10/688,073

Office Action Summary

DETAILED ACTION

FIG. 5

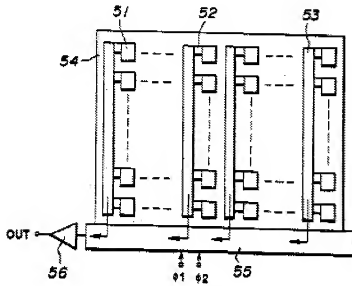
7. Claims 1-2, 4, and 6 are rejected under 35 U.S.C. 102(b) as being anticipated by Wada (US Patent 5,220,185).
8. Regarding claim 1, Wada teaches a solid image capturing element, comprising: a plurality of vertical shift registers (layers 54 in fig. 5) arranged to each correspond to a column of a plurality of light receiving pixels (layer 51) in a matrix arrangement, a horizontal shift register (layer 55) provided on an output side of the plurality of vertical shift registers, and an output section (layer 56) provided on an output side of the horizontal shift register, wherein a semiconductor region of one conductive type (p type layer above layer 11 in fig. 1) is formed closer to a surface (the bottom surface of layer 11) of a semiconductor substrate of one conductive type, while a semiconductor region of reverse conductive type (n layer directly above the p layer) is formed in a deeper portion (deeper into the substrate from the bottom surface of the substrate) than the semiconductor region of one conductive type, and a first semiconductor region (layer 22) and a second semiconductor region of the opposite conductive type (layer 20) and having a higher dopant concentration (n+ has higher concentration than n) than that of the first semiconductor region are formed in the semiconductor region of reverse conductive type, the horizontal shift register (areas in layer 13 and to the right of layer 13 in fig. 1) is formed in the first semiconductor region; and the output section (output amplifier or charge detecting section 21 and 56 in figs. 1 and 5, respectively) is formed in the second semiconductor region.

FIG. 1

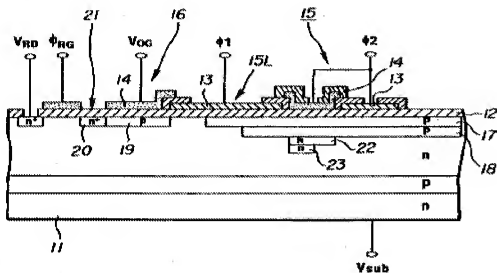
9. Regarding claim 2, Wada teaches the solid image capturing element according to claim 1, further comprising: an output gate (VOG in fig. 1) formed on the semiconductor substrate at a boundary between the horizontal shift register and the output section.

10. Regarding claim 4, Wada teaches a method for manufacturing a solid image capturing element having a plurality of vertical shift registers arranged to each correspond to a column of a plurality of light receiving pixels in a matrix arrangement, a horizontal shift register provided on an output side of the plurality of vertical shift registers, and an output section provided on an output side of the horizontal shift register (see rejection in claim 1), comprising: a first step of forming closer to a surface (the bottom surface of layer 11 in fig. 1) of a conductive semiconductor substrate, a first

reverse conductive semiconductor region (n type layer 23 in fig. 1, which has reverse conductive type than the p type layer above the n type bottom layer) having a first dopant concentration; a second step of forming in a deeper portion (further away from the bottom surface of the substrate) in the conductive semiconductor substrate than the conductive semiconductor region, a second reverse conductive semiconductor region (n+ layer 20) having a second dopant concentration which is higher than the first dopant concentration (n+ has higher concentration than n); and a third step of forming the horizontal shift register (areas in layer 13 and to the right of layer 13, see fig. 1) on the first reverse conductive semiconductor region and the output section (layer 21) on the second reverse conductive semiconductor region.

11. Regarding claim 6, Wada teaches the method for manufacturing a solid image capturing element according to claim 4, wherein a dopant is doped in a stepwise manner (steps formed by two rectangular patches of doped regions—regions 20 and 23, see fig. 1) to the first reverse conductive semiconductor region and the second reverse conductive semiconductor region, and doping of the dopant is performed commonly (when the n layer above the p type well, which is above layer 11, is made) at least once to the first reverse conductive semiconductor region, the second reverse conductive semiconductor region.

FIG. 6

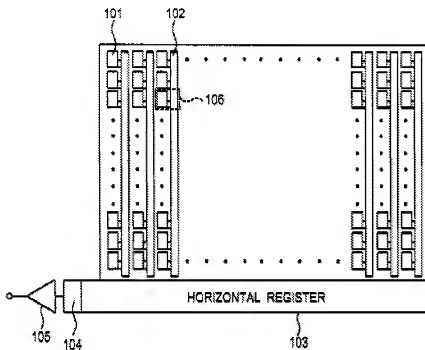
13. Regarding claim 1, Morimoto teaches a solid image capturing element, comprising: a plurality of vertical shift registers (layer 102 in fig. 6) arranged to each

correspond to a column of a plurality of light receiving pixels (layer 106) in a matrix arrangement, a horizontal shift register (layer 103) provided on an output side of the plurality of vertical shift registers, and an output section (fig. 3G) provided on an output side of the horizontal shift register, wherein a semiconductor region (upper surface region of p substrate layer 120 in fig. 3G) of one conductive type is formed closer to a surface of a semiconductor substrate of one conductive type, while a semiconductor region of reverse conductive type (n- layer 121) is formed in a deeper portion (away from bottom surface of substrate 120) than the semiconductor region of one conductive type, and a first semiconductor region (n layer 12) and a second semiconductor region (n+ layer 127) having a higher dopant concentration than that of the first semiconductor region are formed in the semiconductor region of reverse conductive type (n- layer 121), the horizontal shift register is formed in the first semiconductor region; and the output section is formed in the second semiconductor region.

14. Regarding claim 3, Morimoto teaches the solid image capturing element according to claim 1, wherein in the semiconductor region of reverse conductive type (n-layer 121), a third semiconductor region (n-layer 126b) having a lower dopant

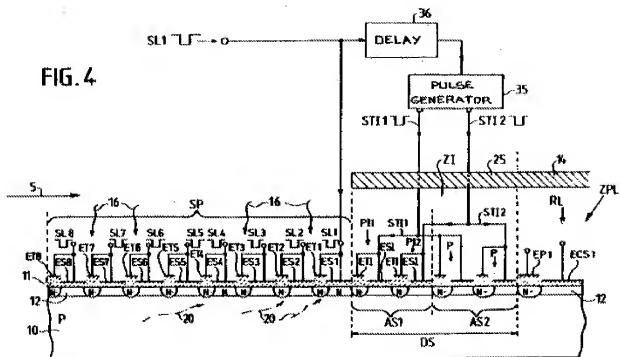
the fourth step, the plurality of light receiving pixels and the plurality of vertical shift registers are formed in the third semiconductor region. In the same field of endeavor, Cazaux teaches forming in a first semiconductor region of reverse conductive type (layer 12 in fig. 4, which is analogous to layer 121 in fig. 3G of Morimoto), a third reverse, conductive semiconductor region (n- layer 20 in fig. 4) having a third dopant concentration which is lower than the first dopant concentration, wherein at the fourth step, a plurality of light receiving pixels and a plurality of vertical shift registers are formed in the third semiconductor region (see fig. 4) for the benefit of eliminating smearing (column 6). Thus, it would have been obvious to one of ordinary skill in the art at the time of the invention to include in the first semiconductor region of reverse conductive type, a third reverse, conductive semiconductor region having a third dopant concentration which is lower than the first dopant concentration, wherein at the fourth step, the plurality of light receiving pixels and the plurality of vertical shift registers are formed in the third semiconductor region for the benefit of eliminating smearing.
